**Eastonville Road – Londonderry Drive to Rex Road
Segment 1 Improvements
Stationing 14+19.69 – 47+66.51**

Final Drainage Report

August 2024

EDARP File No.: CDR2321

6. Inlet / Outlet Works

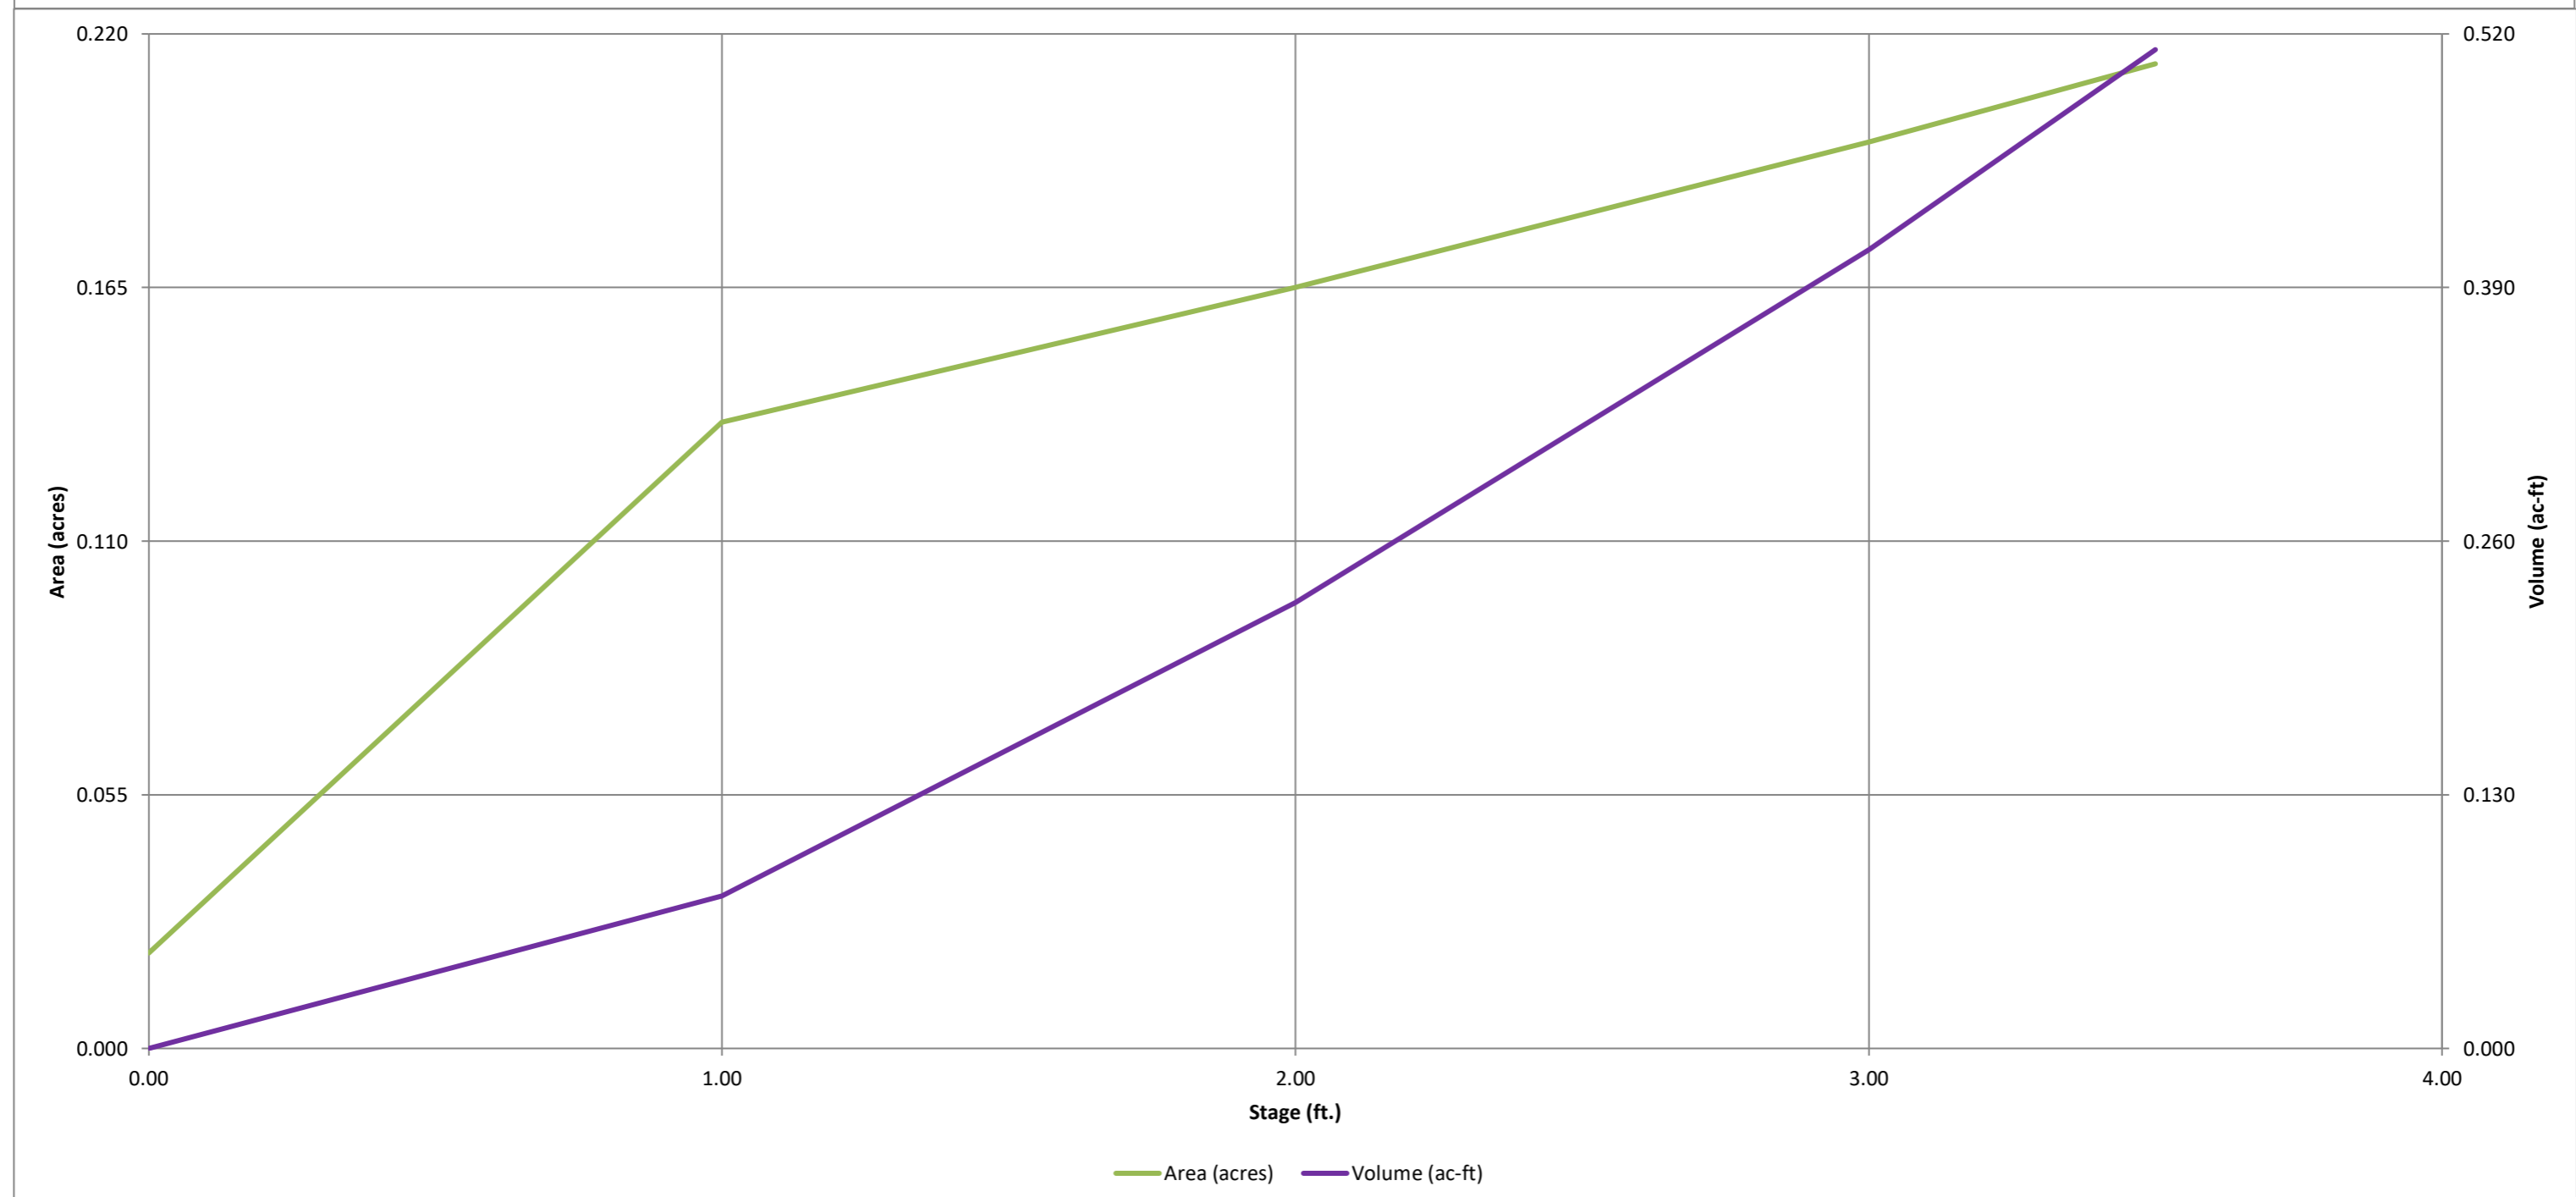
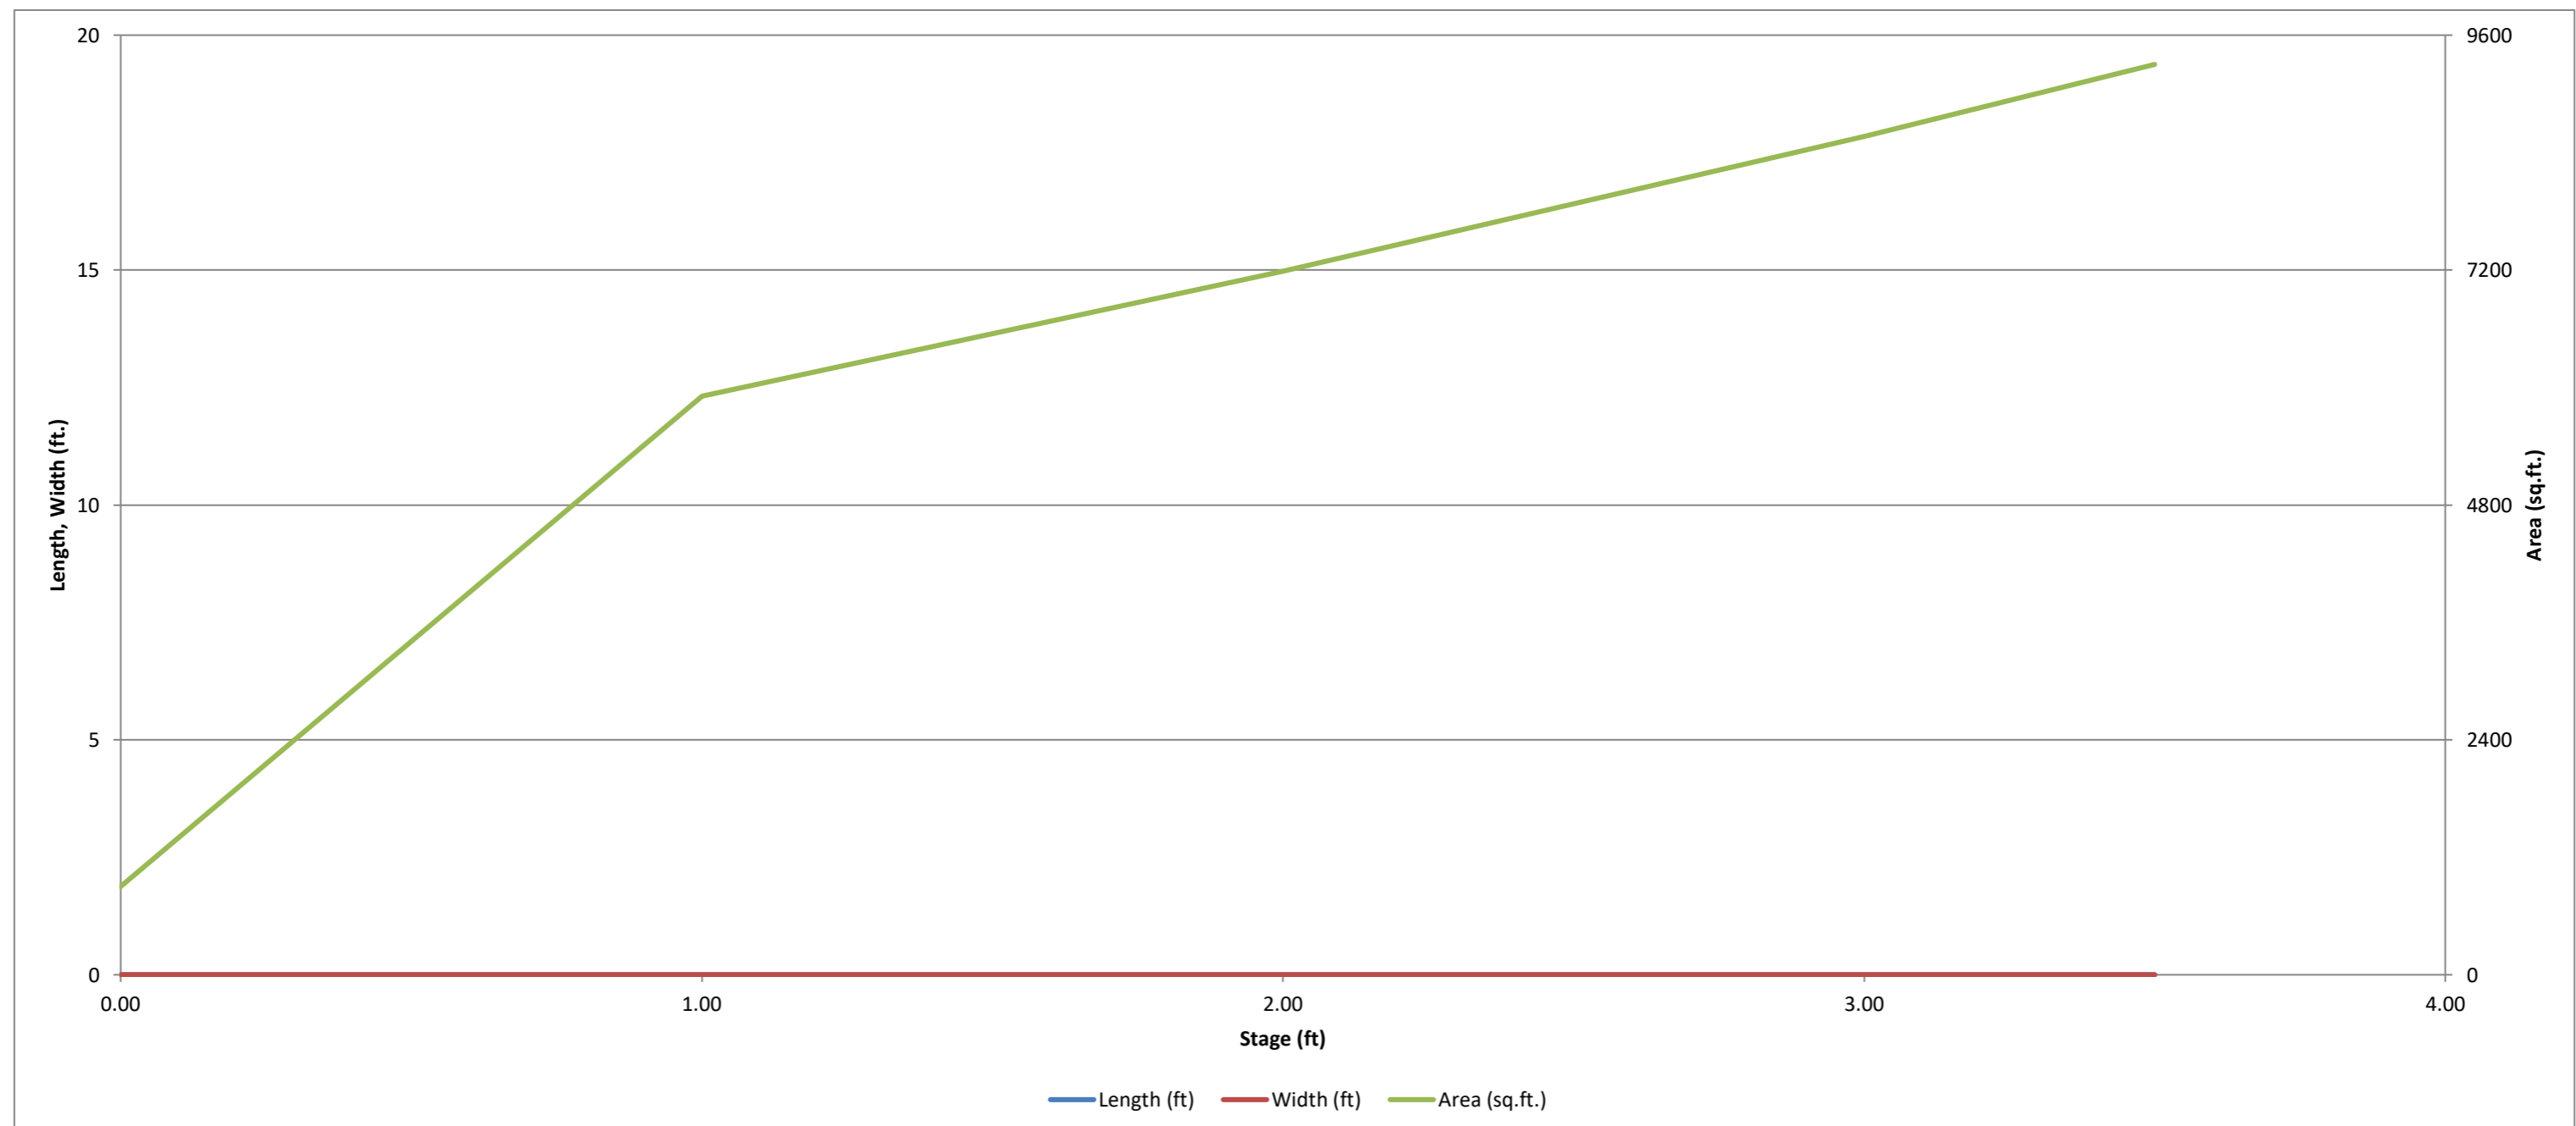
Provide forebay sizing calcs.
